FF2 PARTS LIST

FF2 Design Changes

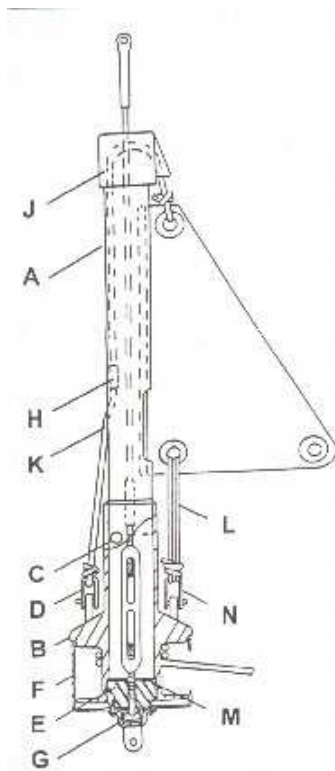
* 1997 New Halyard -- The 3/16 rope halyard with molded-on black plastic traveller has been replaced by part # 1932. The new halyard (1932) uses a 1/4" rope with a stainless steel ferrule swaged on. Both halyards function in the same way and are interchangeable.

** 1998 Downhaul/Halyard Shackles -- The eyemount where the halyard is made fast has been replaced by a shackle that stands on the top flange of the spool. The eyemount is still available (part # 1422, \$7).
